Re: ENERGY STAR Program Requirements Product Specification for
Residential Refrigerators and Freezers, Eligibility Criteria, Draft 2, Version 5.0

On behalf of the Association of Home Appliance Manufacturers (AHAM), I would like to provide our comments on the ENERGY STAR Program Requirements Product Specification for Residential Refrigerators and Freezers, Eligibility Criteria, Draft 2, Version 5.0.

Possible
Connections
for
Connected Refrigerator
System

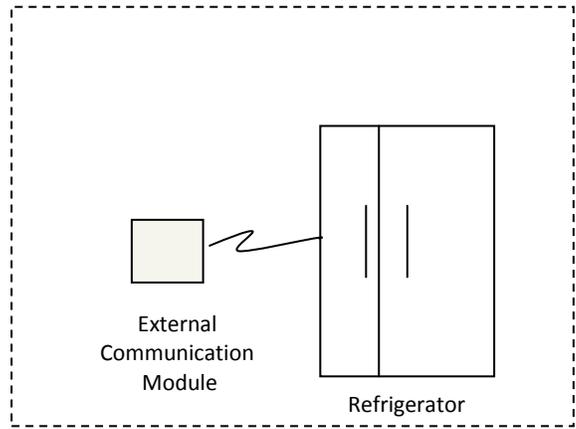
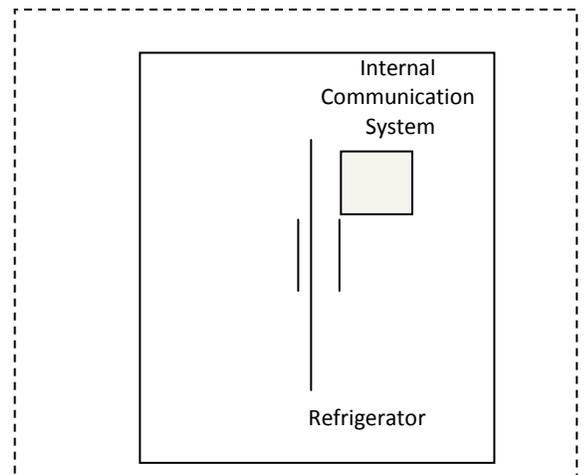
The first paragraph of Section 4 provides an overview; however, additional language is needed for clarification on the discussion for the system under consideration. AHAM proposes to include the following in order to define the system boundaries: “The connected refrigerator is an appliance that provides all the necessary hardware and software for communications.” For further clarification, below is a diagram to illustrate the connected refrigerator system boundaries.

EPA proposes to title this section “Home Energy Management (HEM) Functionality.” This title is confusing. When defining the system boundaries as above, it should not be the intent to include home energy management functionality in this standard, only the ability to connect and communicate with a home energy manager external to the system under consideration. A more accurate title might be “Connectivity to Support Home Energy Management.”

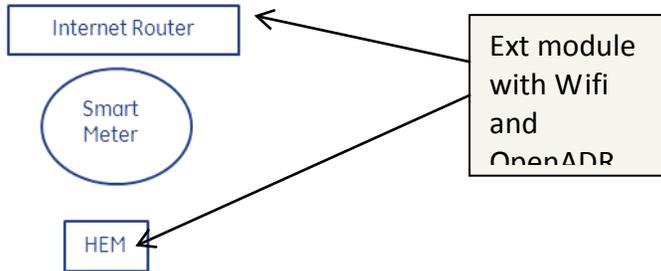
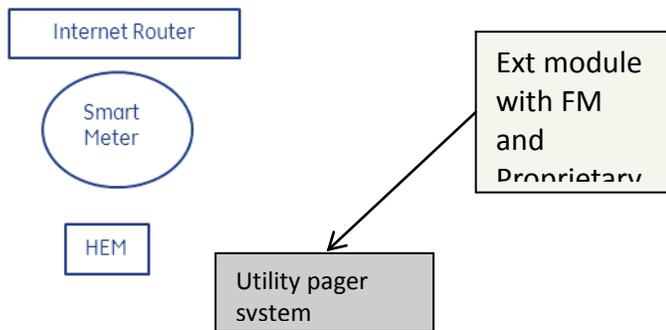
EPA proposes, in Section D.1, to provide an exception to providing a modular interface for demand response functionality which is confusing and the intent for the exception is not clear. By providing the exception, the language in the specification seems to indicate that if the interface is compliant with any standard from the listed organizations (NIST, ANSI, ISO) the module itself is not necessary. This approach is not consistent with the intent to provide the consumer with a product that is operational upon receipt. Such an approach is very limiting and may not enable communications with a HEM thus disabling Sections 4A & 4D and potentially impact 4B based on the architecture selected by the manufacturer (see diagram).

This diagram illustrates an original product design with Wifi and OpenADR versus replacing in the lower diagram with a module utilizing FM and proprietary protocols for which the product was not originally designed. Per EPA’s definition in Section 4.D, a device can provide a communication method to enable 4C that is no longer compatible with 4A, B, or D.

By swapping out the module required to one that meets the minimum specified by 4C, it is possible to no longer be compliant with Section 4A, 4B and 4D

4A – cannot talk to HEM

4B – can't get time from internet

4D – remote no longer possible by original architecture...
